**City of Bellevue
Development Services Department
Land Use Staff Report**

Proposal Name: Chaffey Short Plat

File Number: 20-123369-LN

Department Decision: **Approval with Conditions**

Figure 1 – Preliminary Short Plat Proposal

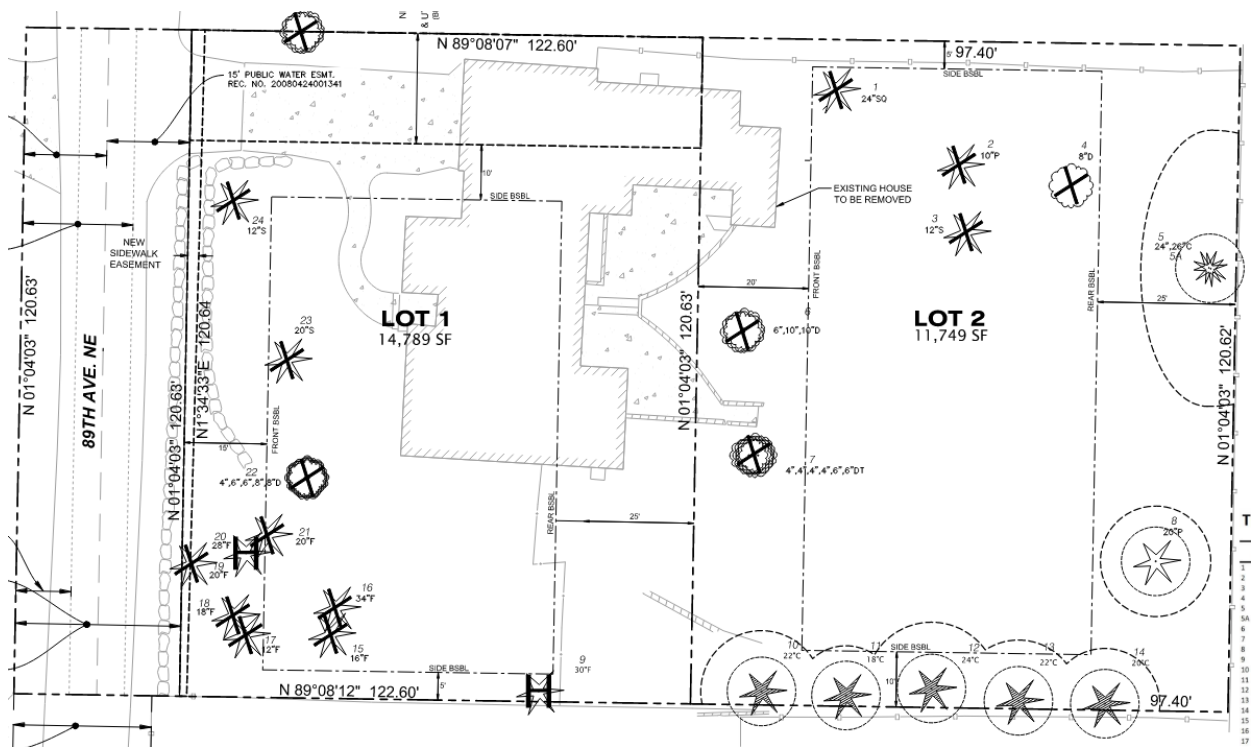
The applicant is proposing to subdivide an existing parcel (26,538 square feet) into two single-family lots (14,789 and 11,749 square feet). The site is zoned R-3.5 (a single-family zoning district) and is located within the North Bellevue Subarea. The minimum lot size in R-3.5 zoning district is 10,000 square feet. The site contains an existing single-family home that will be removed as part of the proposal. Access to the two lots will be from 89th Ave NE using a shared driveway. An access easement will be located at the north of Lot 1 for the shared driveway access to Lot 2.
